UNITED STATES PATENT AND TRADEMARK OFFICE

APPLICATION NO.	FILING DATE	FIRST NAMED INVENTOR	ATTORNEY DOCKET NO.	CONFIRMATION NO.
10/788,621	02/27/2004	Christopher J. Kowalsky	DKT03160	6497

Office Action Summary

DETAILED ACTION

FIG. 3

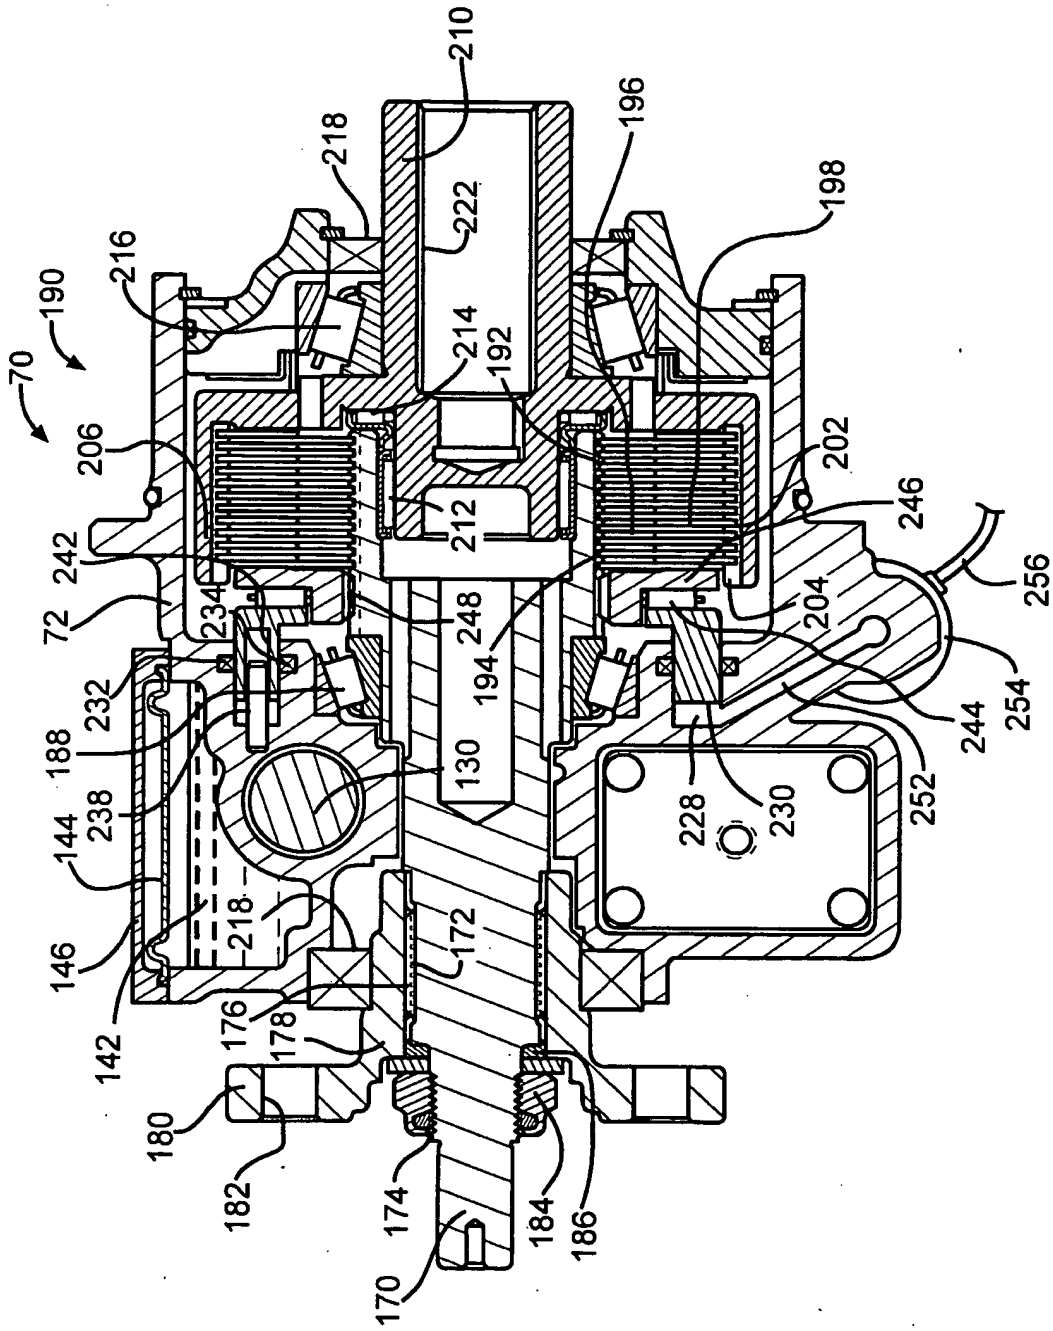
The replacement sheet of drawings showing a corrected Fig. 3 was received on August 15, 2005. These replacement sheet is acceptable.
